**SHINE MEDICAL TECHNOLOGIES, LLC OPERATING LICENSE APPLICATION
SUPPLEMENT NO. 2**

**FINAL SAFETY ANALYSIS REPORT CHANGE SUMMARY
PUBLIC VERSION**

FINAL SAFETY ANALYSIS REPORT MARKUP

Figure 7.4-1 – TRPS Logic Diagrams
(Sheet 10 of 14)

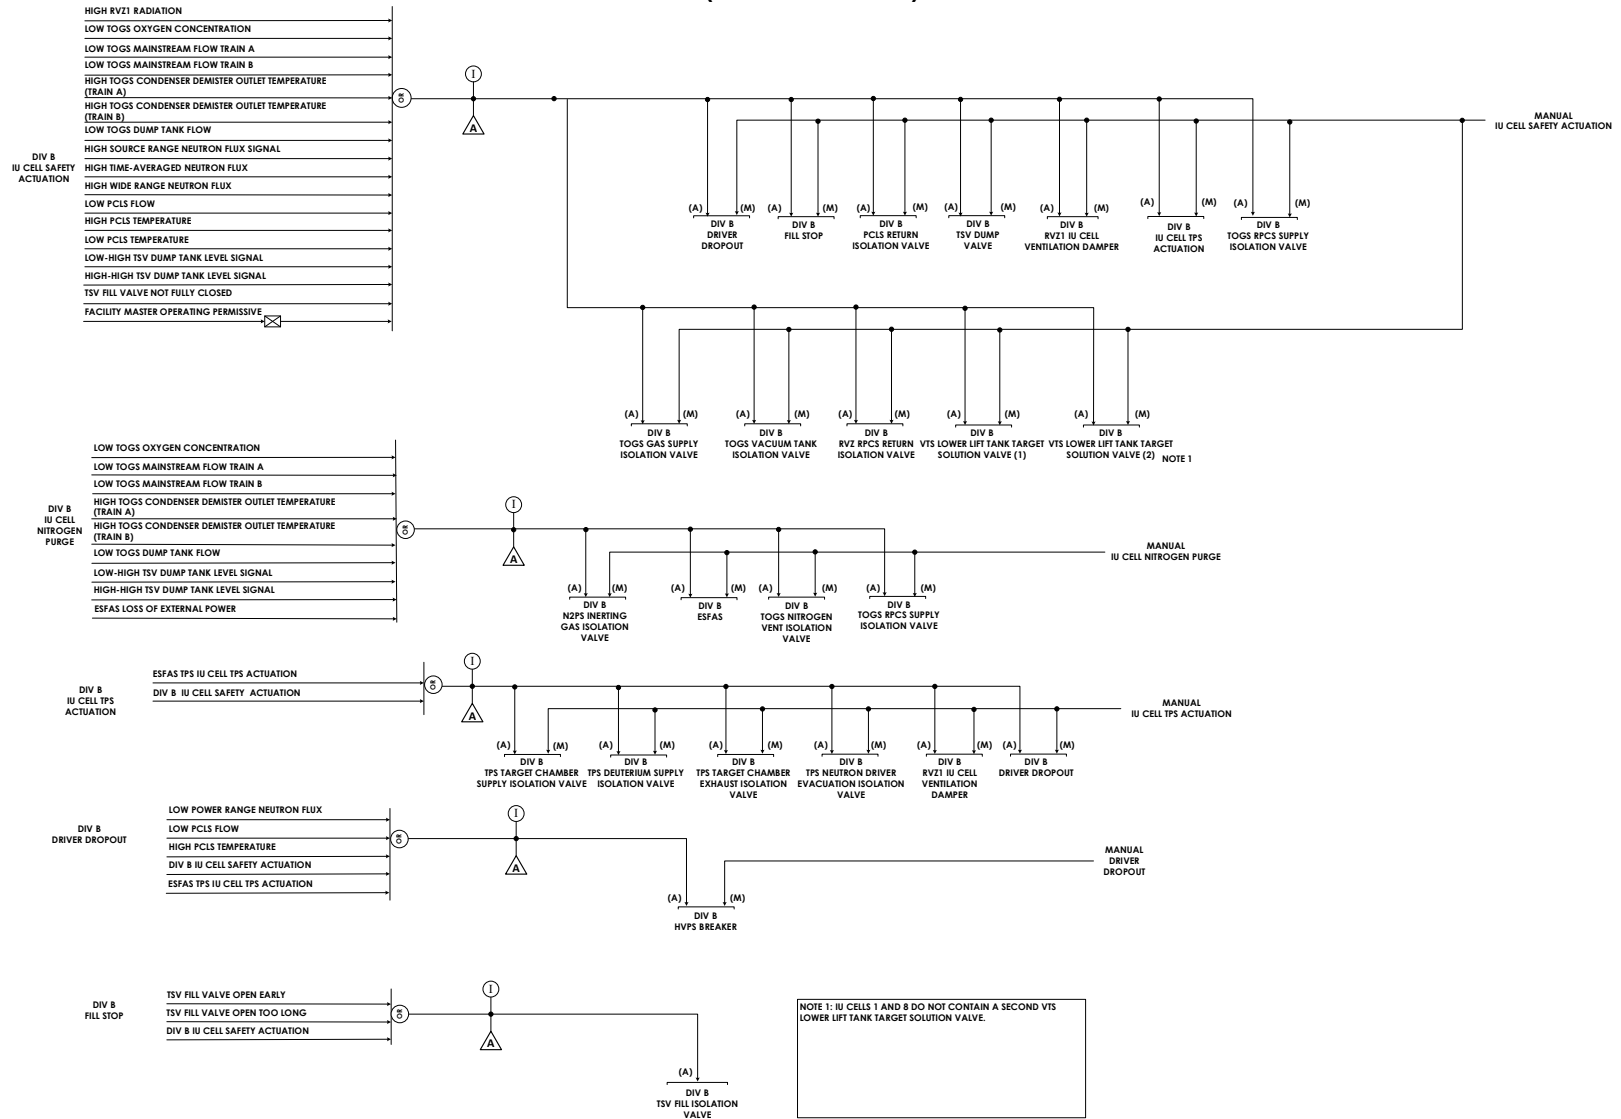
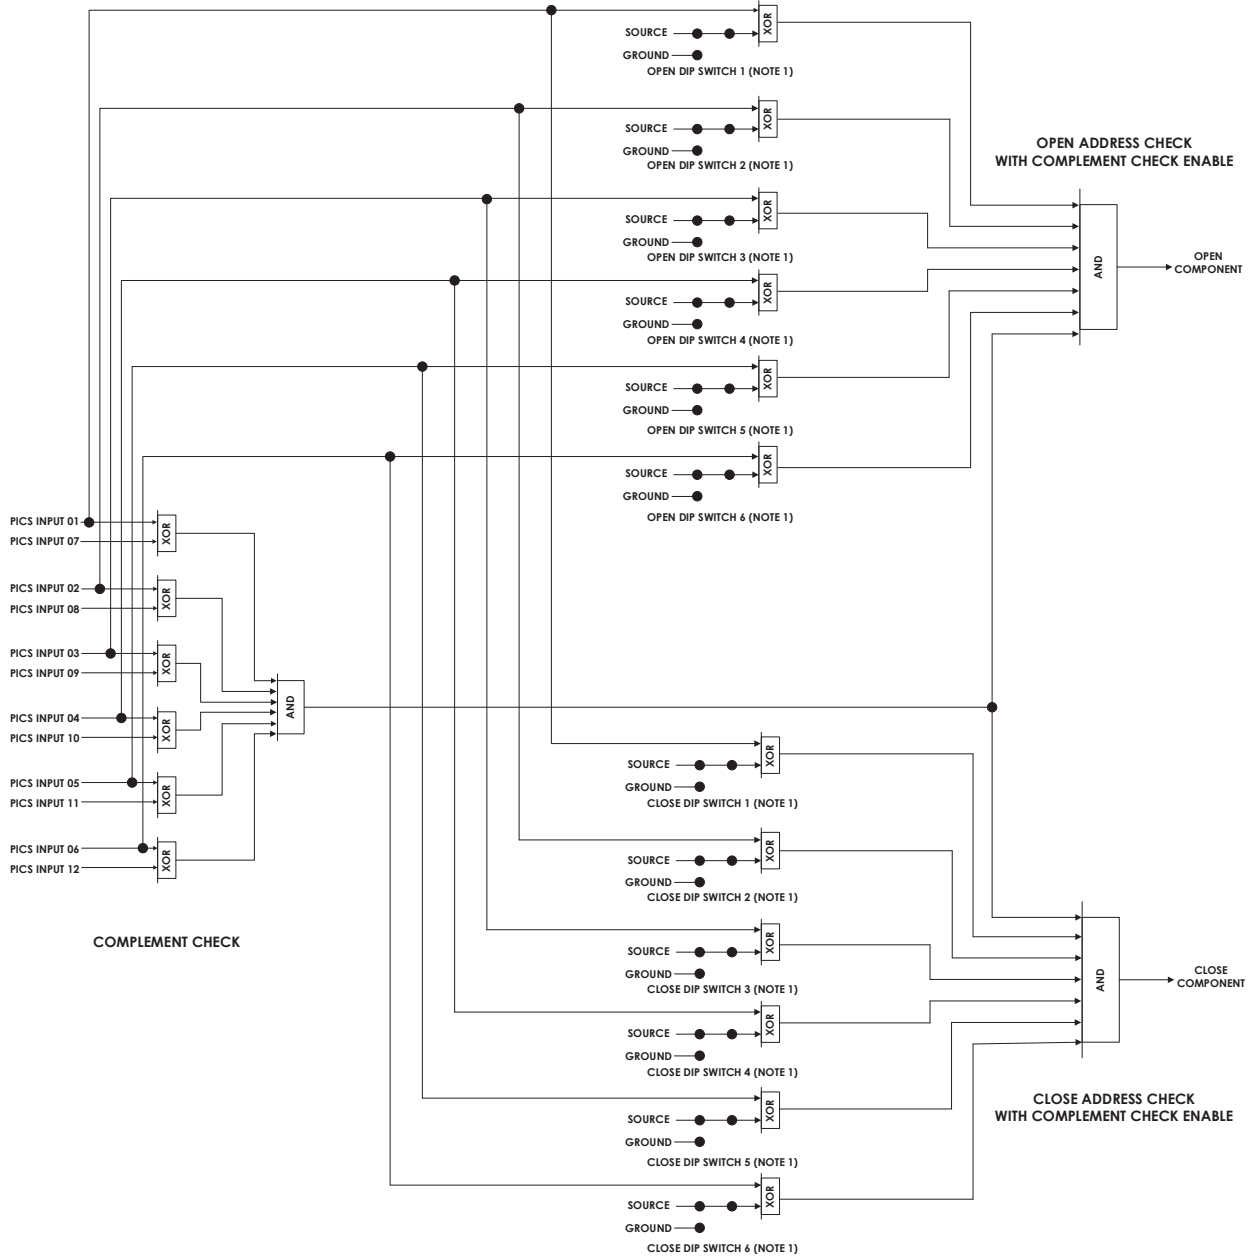
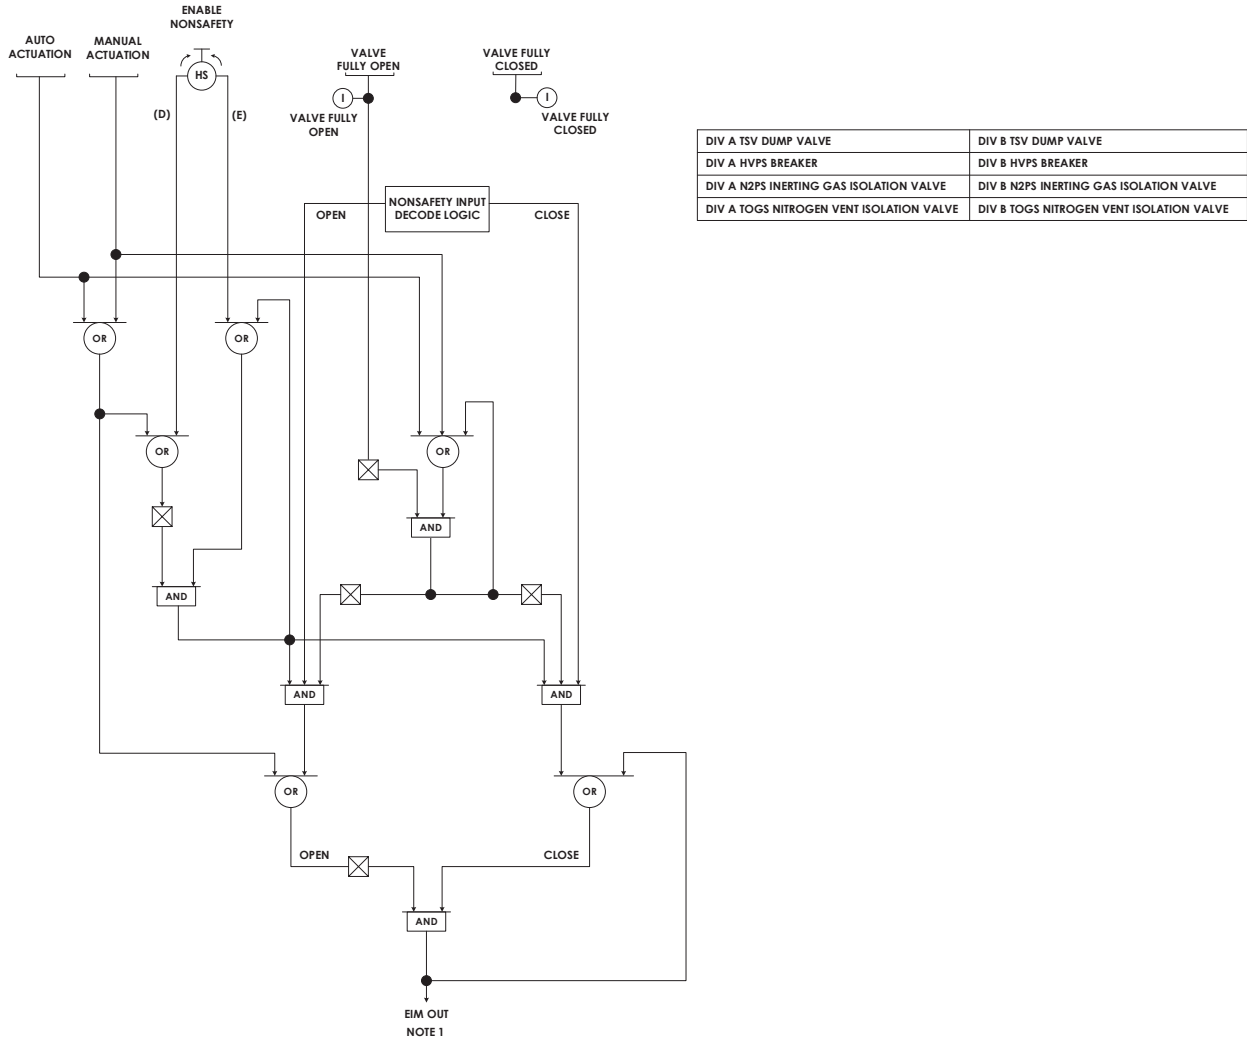
<p>Update to incorporate primary closed loop cooling system (PCLS) design changes. The PCLS design has been updated to incorporate SHINE design criteria 34, confinement isolation. This change improves the reliability of PCLS isolation safety functions.</p>	<p>Table 3.1-1, Section 5a2.2, Figure 5a2.2-1, Section 7.4, Figure 7.4-1</p>

~~Figure 7.4-1, Sheet 11 and Sheet 12,~~ shows how the TRPS latches in a protective action and maintains the state of a protective action until operator input is initiated to reset the output of the TRPS.

Figure 9a2.1-2 – Radiological Ventilation Zone 1 Recirculating Cooling Subsystem (RVZ1r) Flow Diagram

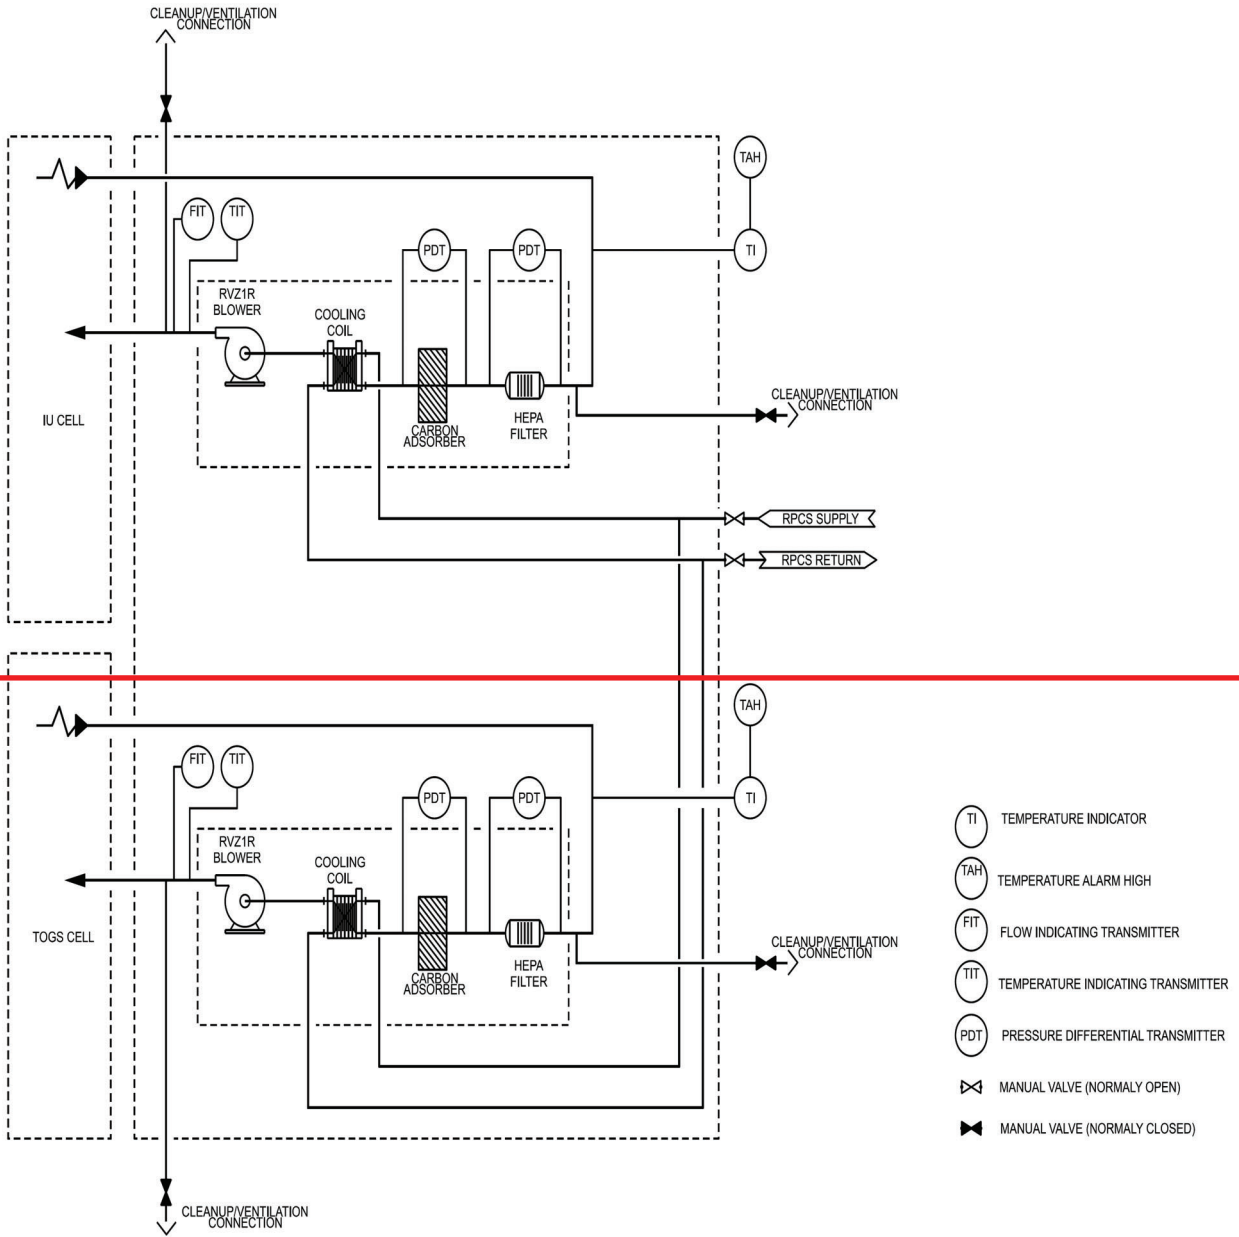
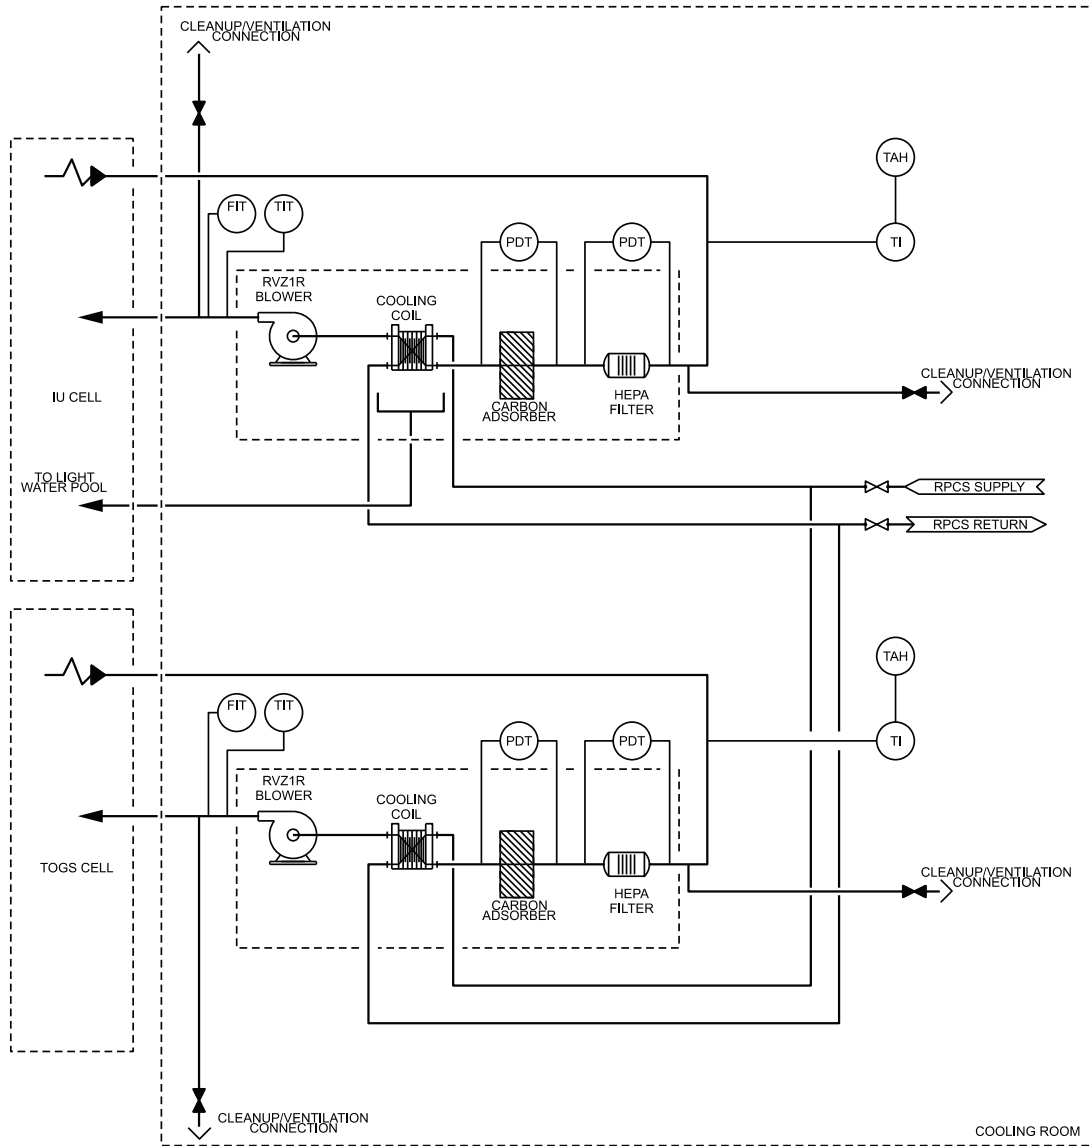
Summary Description of Changes	FSAR Impacts
<p>Update to incorporate irradiation facility (IF) cooling room design changes (i.e., applicable to eight cooling rooms, one for each irradiation unit [IU] cell). The cooling room design has been updated to remove the wall separating PCLS equipment from radiologically controlled area ventilation (RVZ) equipment. The wall is not needed to provide structural, shielding, or confinement functions. Several figures that are updated to remove the cooling room wall have also been updated to incorporate additional changes, including: TPS room expansion, addition of room labels, and removal of precast tank vault depictions.</p>	<p>Figure 1.3-1, Figure 1.3-2, Figure 3.4-7, Figure 4a2.1-1, Section 4a2.5, Figure 4a2.5-1, Section 6a2.1, Section 6a2.2, Figure 6a2.2-1, Section 9a2.1, Figure 9a2.1-1, Figure 9a2.1-2, Figure 11.1-1, Figure 11.1-2, Section 13a2.1</p>
